STATE	PROJECT NO.	YEAR	SHEET NO.	TOTAL SHEETS
KANSAS	54-87 K-6675-01	2002	412	1122

PLAN AND PROFILE - 3.4 x 2.4 m R.F.B.

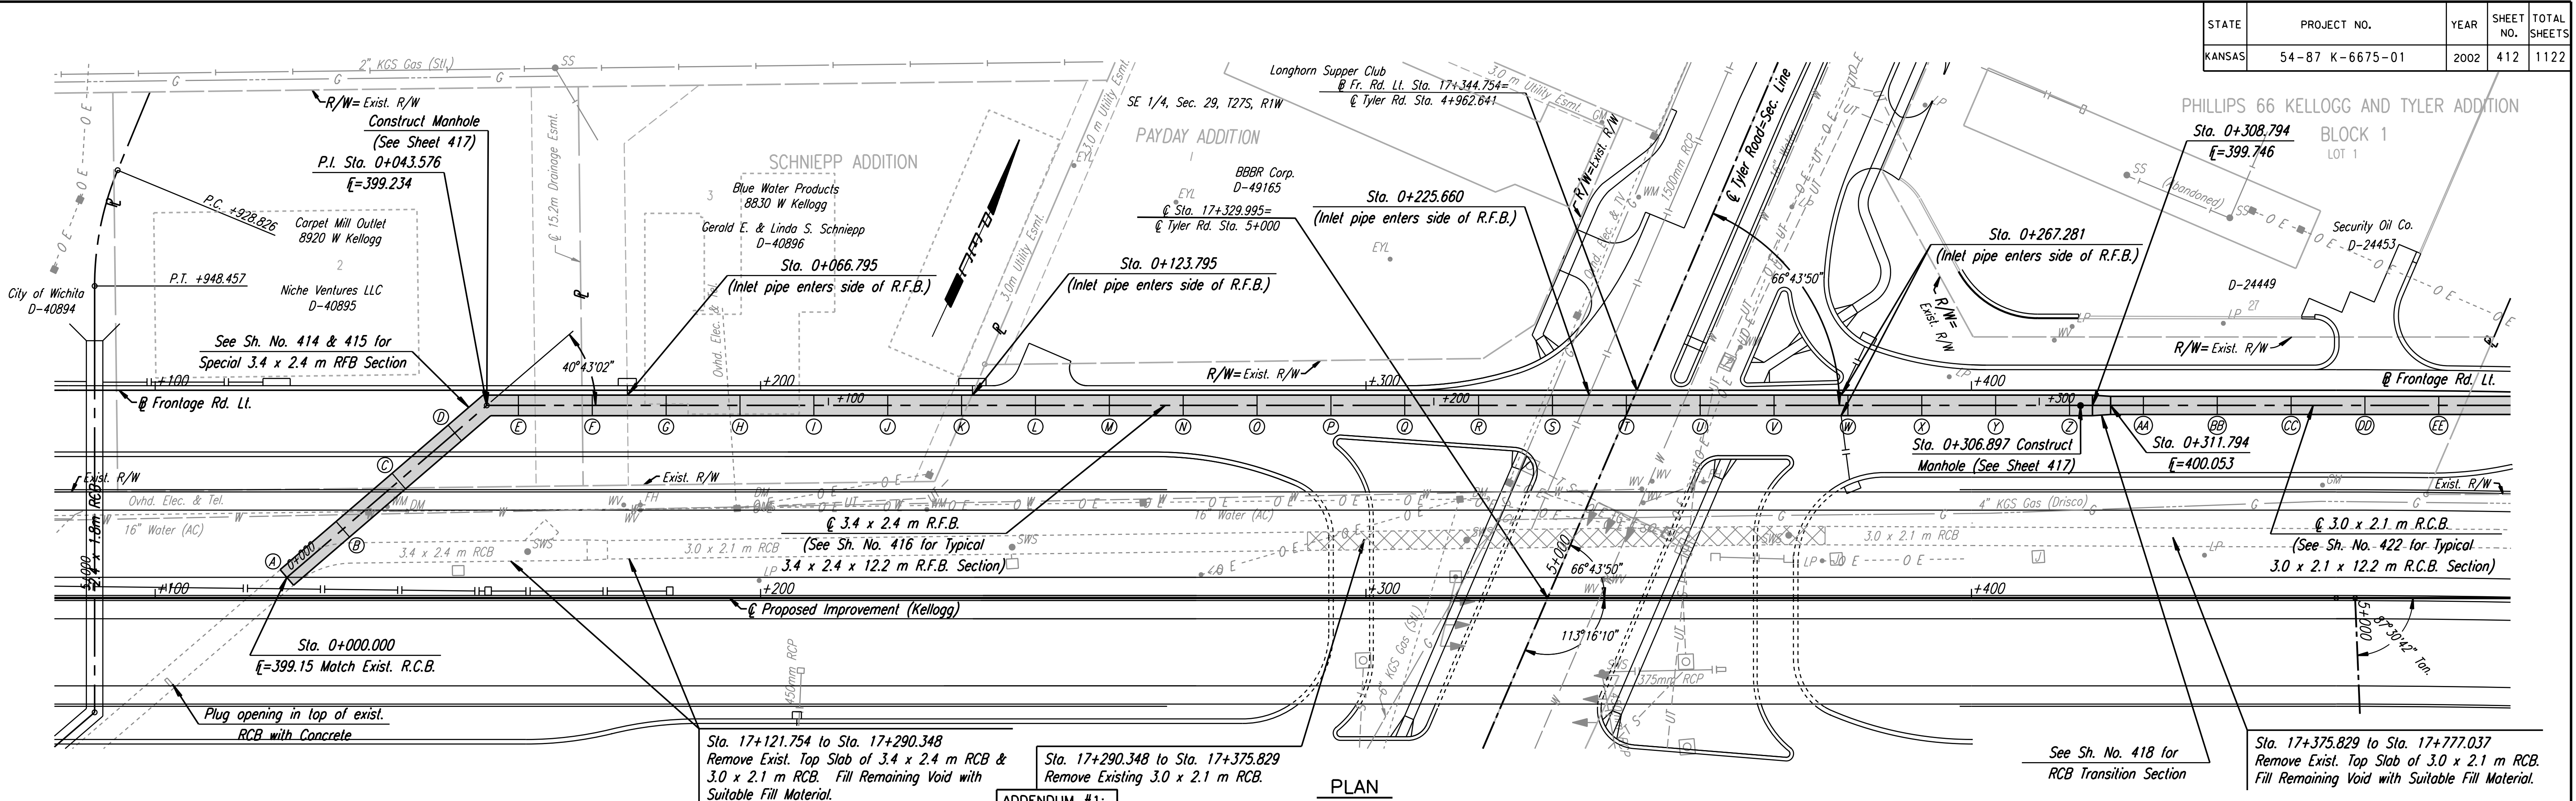
ADDENDUM #1:
 Sheet 412 Add the following notes:
 1. The existing RCB shall be entirely removed where it conflicts with construction of the proposed RFB/RCB and the abutments and piers of the Tyler Road Bridge. The RCB may remain in place under Tyler Road where it does not conflict with proposed construction however, it shall be plugged and sand or grout filled using methods approved by the Engineer. All work associated with removal and/or abandonment of the existing RCB including tools, materials, excavation, backfilling, labor and incidentals necessary to complete the work, shall be included in the Lump Sum contract price for "Removal of Existing Structures".
